ATLANTIC CROSSING

Project Number: 217093

#### CLASS II MODIFICATION 2019 - 8.2.2019

PLAZA SUPPLEMENTAL EXHIBITS

### BLDG III FIRST & SECOND FLOOR PLANS

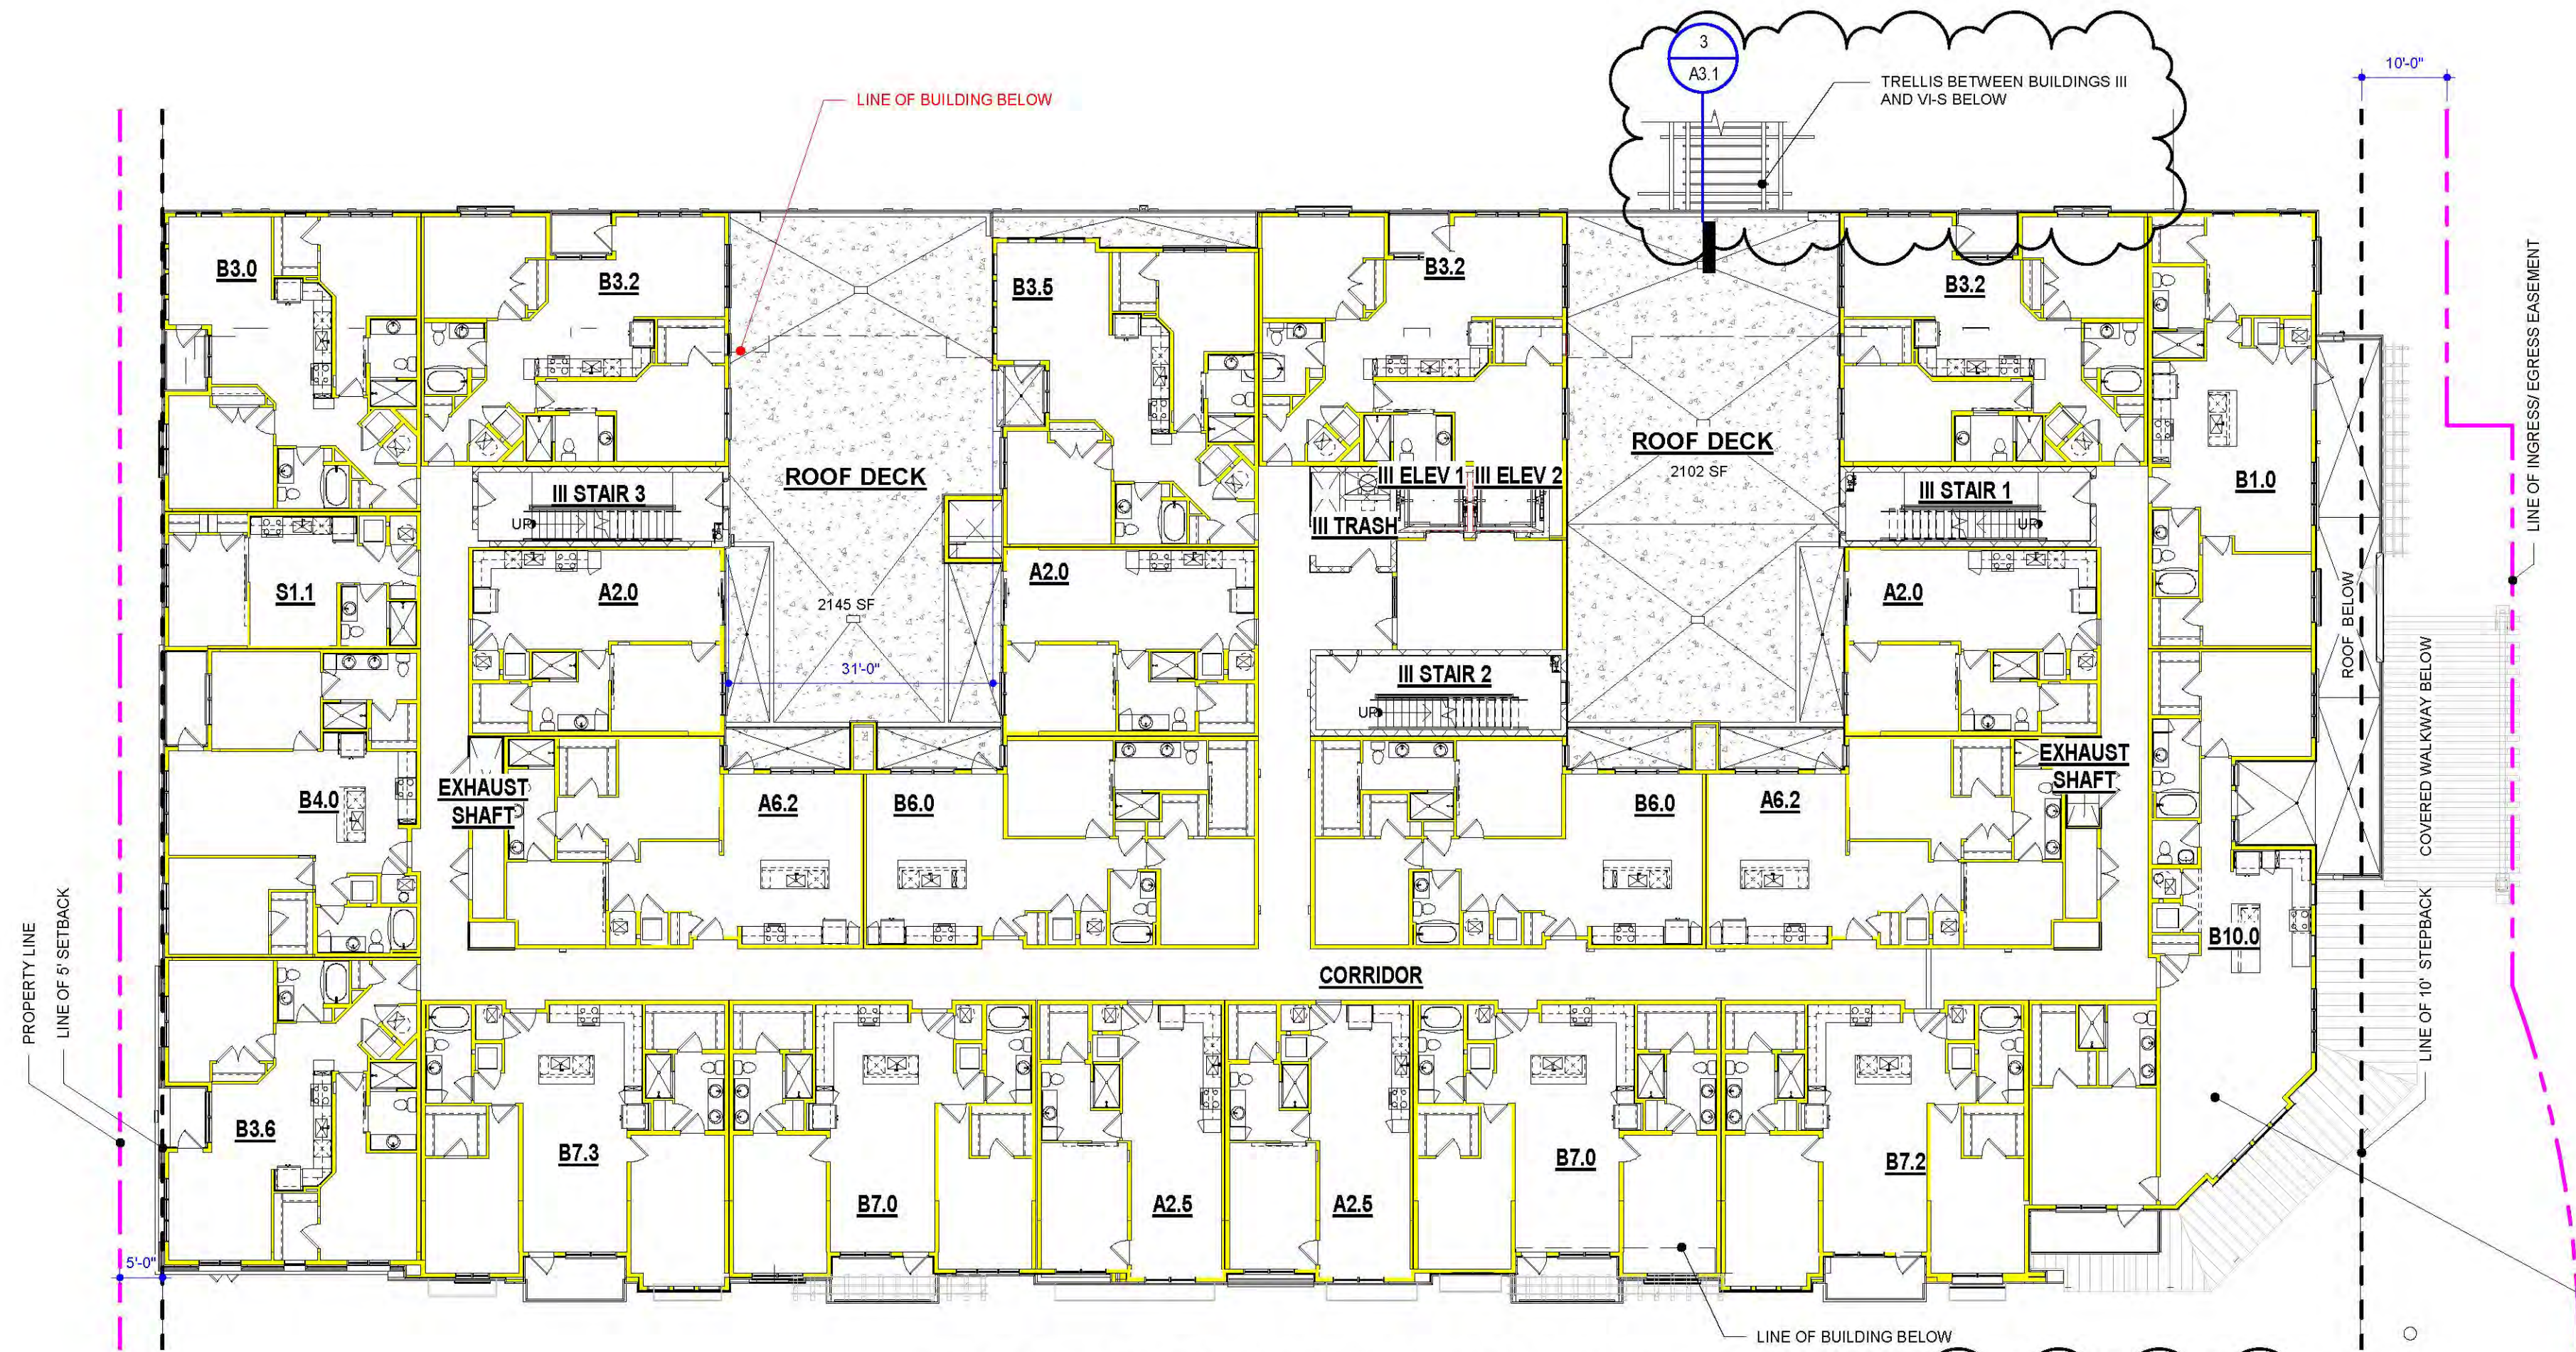
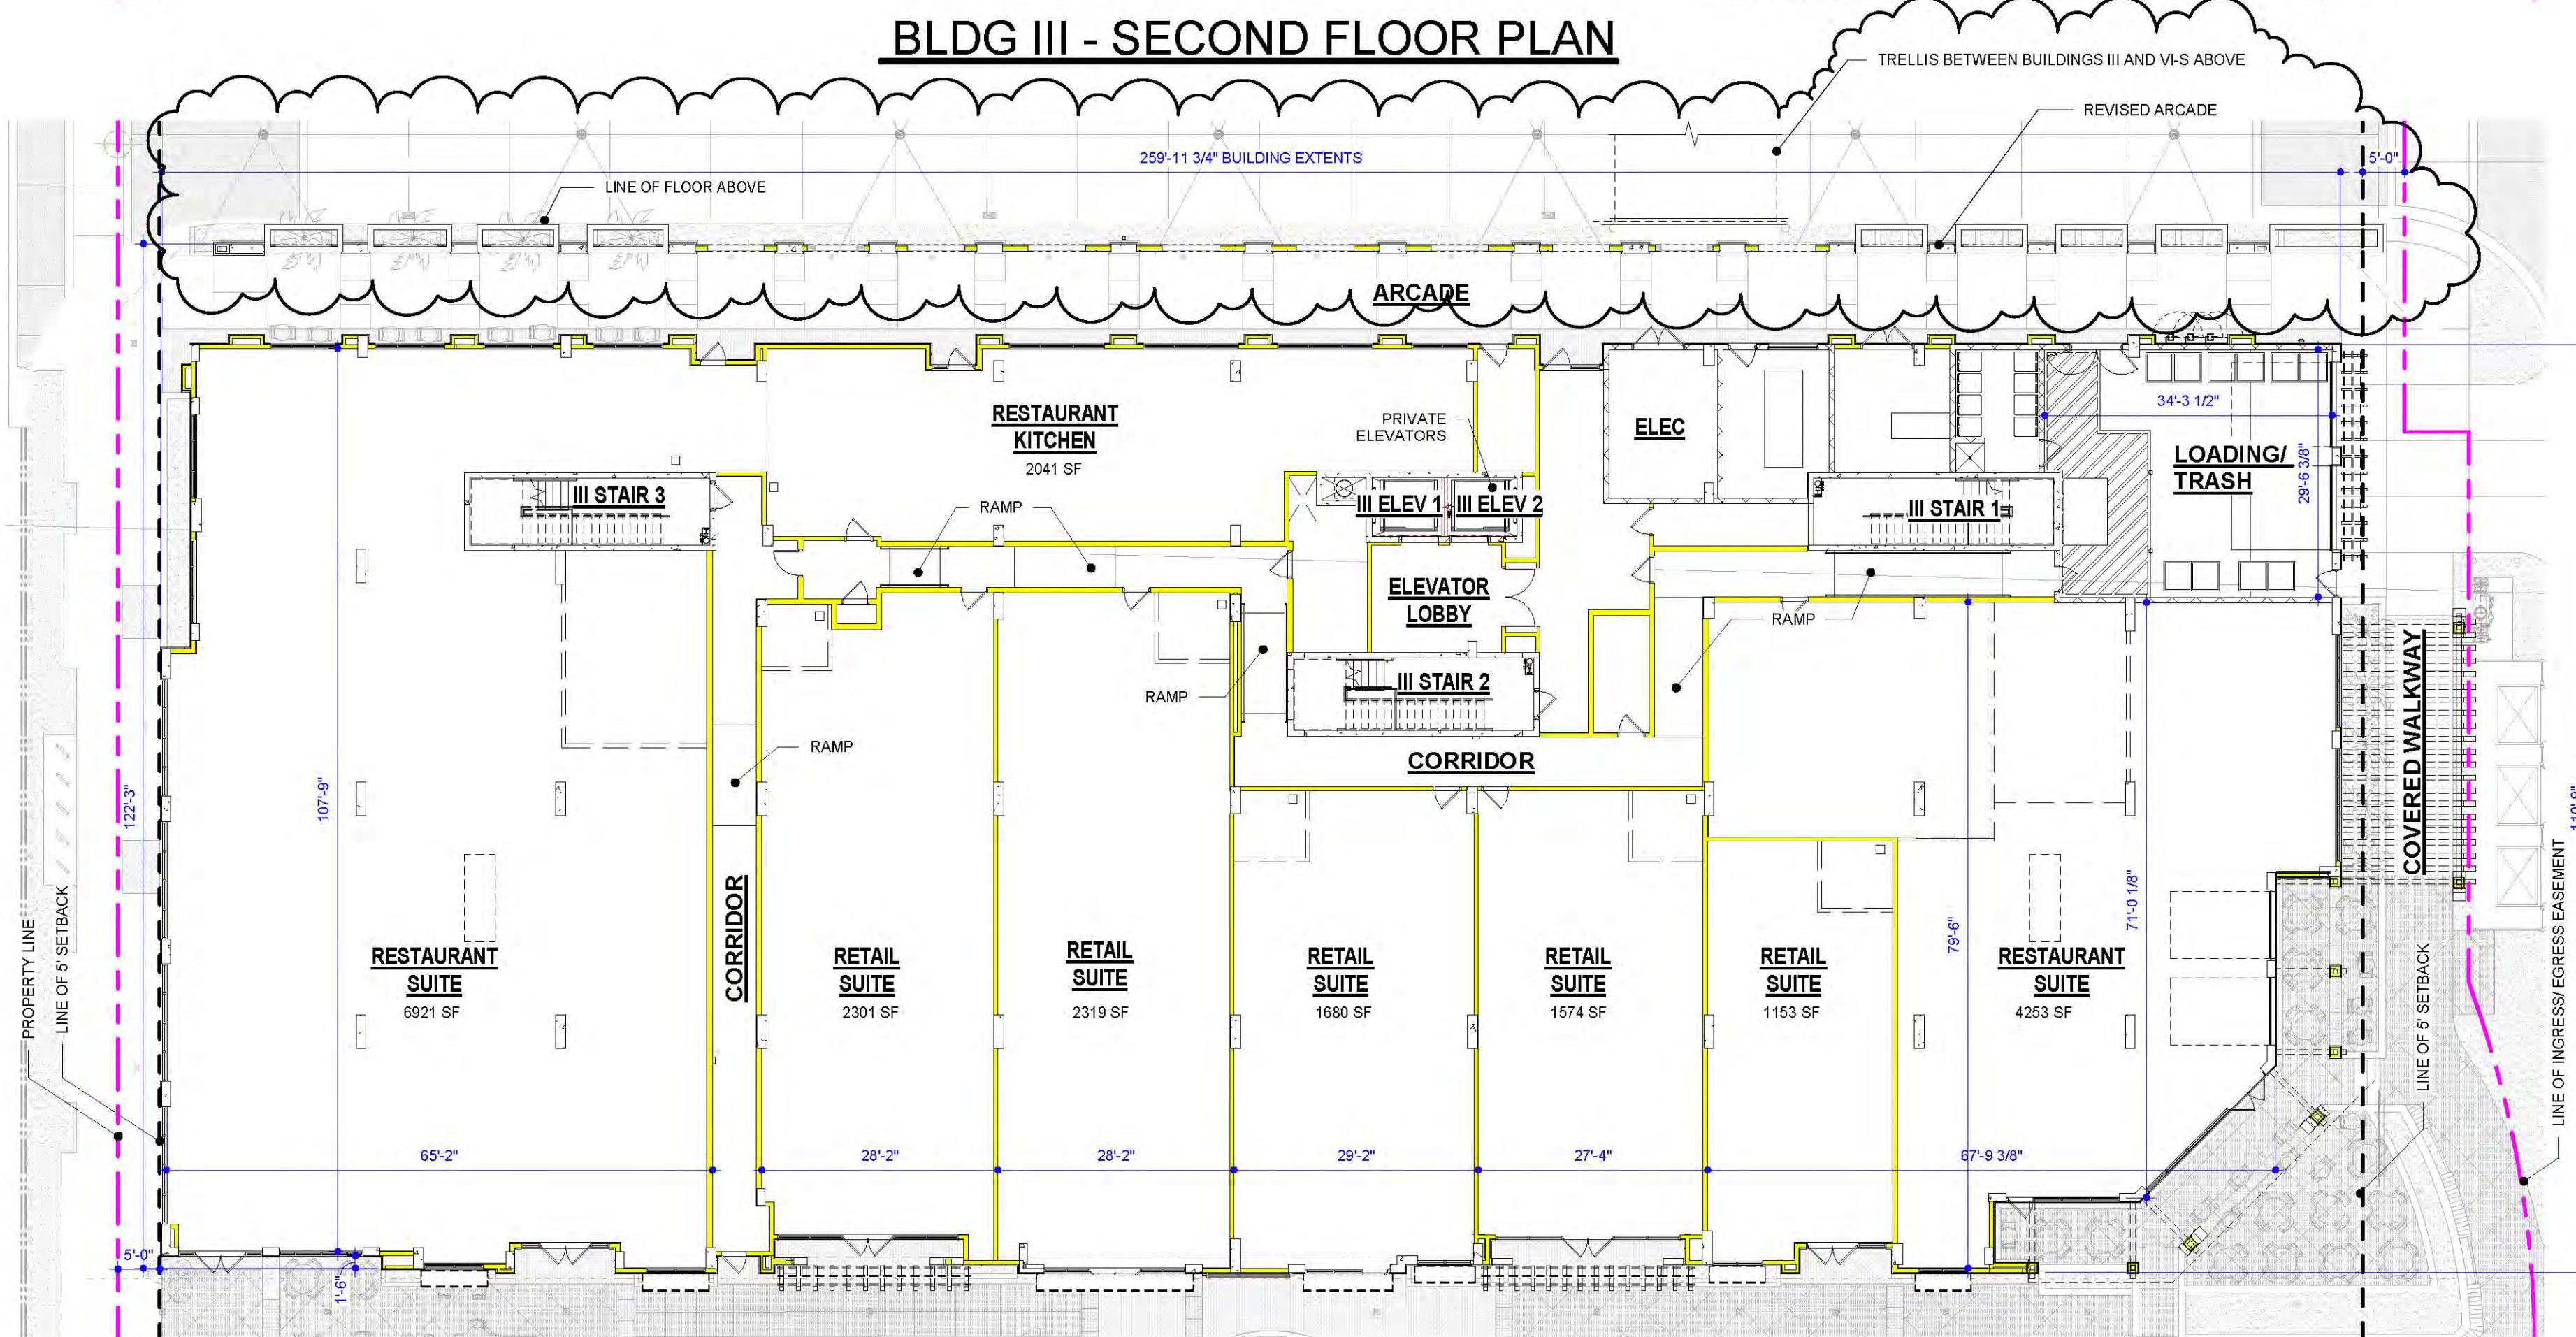
- BUILDING III NORTHWEST FOOTPRINT ADJUSTED DUE TO ADDITION OF RAMP AT NE 8TH AVENUE
- ADJUSTED EASEMENT LINE ON WEST SIDE OF N.E. 7TH AVE.
- FLOOR PLANS REFLECT RESIDENTIAL UNIT COUNTS.

- REFORMATTED UNIT MATRIX
- SETTLEMENT MODIFICATION 4.21.2017
- ADD ARCADE TO THE NORTH AND REDUCED SQUARE FOOTAGE ACCORDINGLY
- DELETED CANTILEVER ON NORTH AT SECOND FLOOR

- REVISE DETAIL AT ARCADE
- ADD TRELLIS BETWEEN III & VI-S

- CLARIFY GRAPHICS
